REVISED RESPONSE TO REQUEST FOR ADDITIONAL INFORMATION

APR1400 Design Certification

Docket No. 52-046

RAI No.: 182-8160
SRP Section: 03.07.01 – Seismic Design Parameters
Application Section: 3.7.1
Date of RAI Issue: 08/31/2015

Figure 15 Comparison of Minimum-Required Target PSD for Horizontal Time History and PSD of Time History of Truncated Duration from 4.2 sec to 16.8 sec for CSDRS-EW

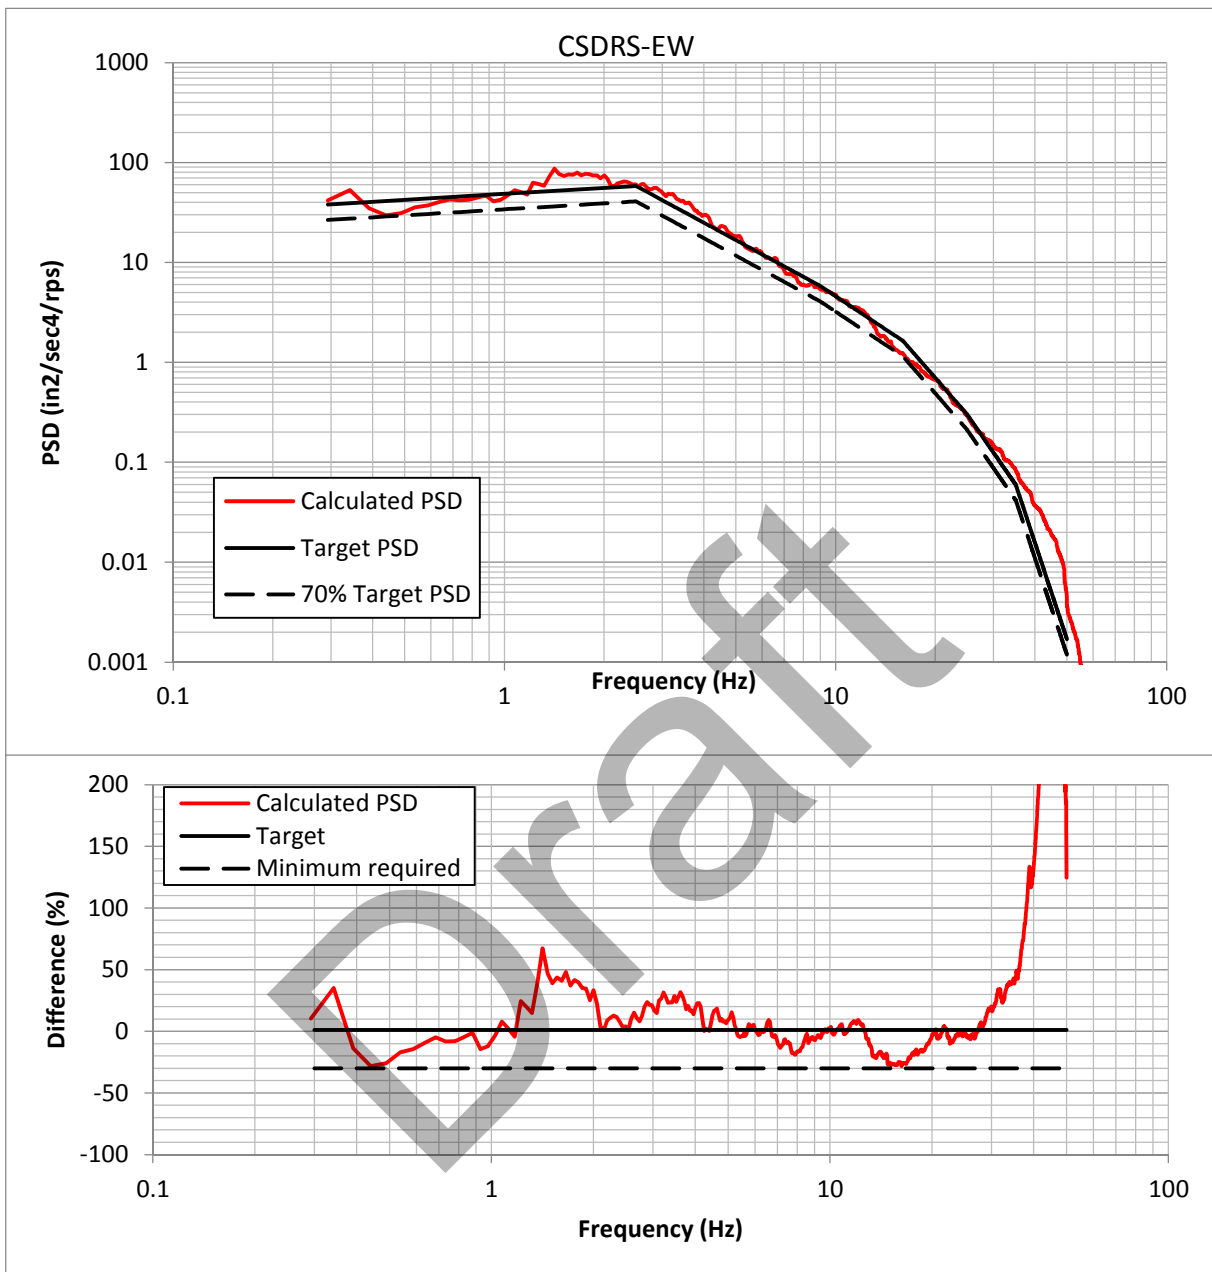
In DCD Section 3.7.1.1.2, the PSDs of the design acceleration time histories are compared to the corresponding target PSD. However, the method to estimate the PSD from an acceleration time history is not provided. Therefore, the applicant is requested to provide a description of the method for the PSD estimation and justify any difference of the method as compared to the guidance provided in SRP 3.7.1. The provided information should include the definition of the strong motion duration, portion of the time history used to compute the Fourier spectra, PSD smoothing, and any normalization parameters used in Fourier transform and PSD calculation.

The PSDs for time histories of truncated duration are computed in accordance with Appendix B of SRP 3.7.1, Rev. 4. The strong motion durations for the CSDRS compatible time histories are defined as shown in Figures 10 through 12. Using the truncated time histories and the corresponding the strong motion duration, the PSDs for the CSDRS compatible time histories are computed as shown in Figures 13 through 21. The PSDs for the CSDRS compatible time histories envelop 70% of target PSD as

shown in Figures 15, 18, and 21. Thus, the PSDs for the CSDRS compatible time histories satisfy the requirement of Appendix B of SRP 3.7.1, Rev. 4.

Figure 22 Comparison of PSDs between Time History of Full Duration and Time History of Truncated Duration for CSDRS-EW

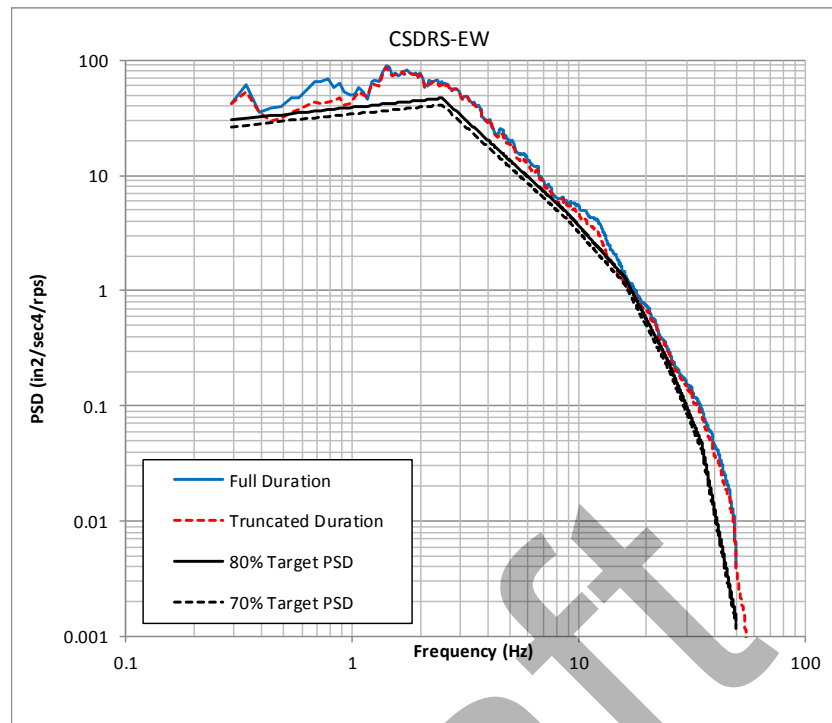
Appendices A and B of SRP 3.7.1 indicate that PSD should be estimated based on the strong motion duration. Therefore, the staff requests that the applicant provide a justification for the use of equivalent stationary strong-motion duration. Similarly, the applicant is requested to explain why the entire time histories were used in the Fourier transform. The use of the equivalent stationary strong-motion duration, which is shorter than the entire duration as shown in Figure 3-27 of APR1400-E-S-NR-14004-P, Rev. 1, together with the entire time history used in the Fourier transform, may overestimate the PSD for those frequencies that have very low magnitude but span the entire time history

As shown in Figure 22 through 24, it can be concluded that the use of full-duration time history and the corresponding 0% to 100% extended equivalent stationary duration $T(100\%-0\%) = T(75\%-5\%)/0.7$ to compute the time-history PSD is a convenient and valid procedure to generate the time-history PSDs.

Figure 30 Comparison of Minimum-Required Target PSD for Horizontal Time History and PSD of Time History of Truncated Duration from 3.0 sec to 10.5 sec for HRHF-EW

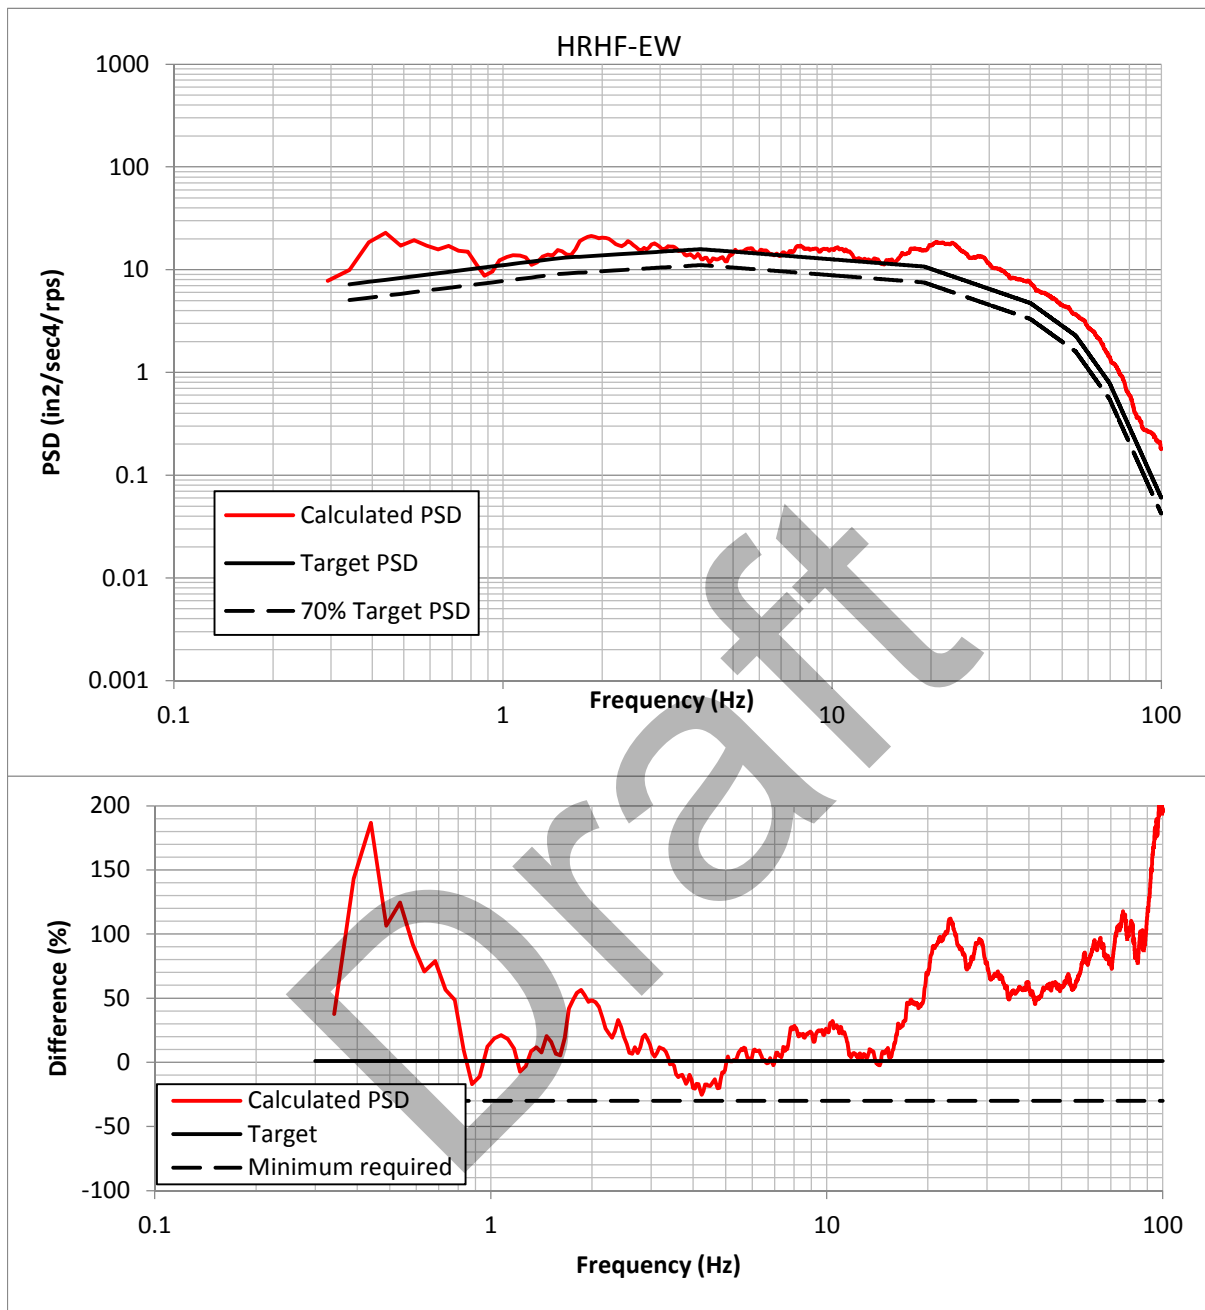
constant slope S.” In this statement, the parameters P1, P2, and S are not defined. As such, the applicant is requested to provide these three parameters for the three HRHF acceleration time histories. In addition, it appears that the PSD estimate is very sensitive to the choice of P1 and P2; for example a P1=0 and P2=100% will lead to an equivalent stationary strong-motion duration T_s equal to the total duration of the time history. As such, the applicant is also requested to provide a justification for the values of P1 and P2.

The PSDs for the HRHF RS compatible time histories are computed using the procedure which is described in response to Question 03.07.01-3 (a) as shown in Figure 25 through 36. The PSDs for the HRHF RS compatible time histories satisfy requirement of Appendix B of SRP 3.7.1, Rev. 4 as shown in Figure 30, 33, and 36. The comparison of PSDs between using full duration and truncated durations are shown in Figure 37 through 39.
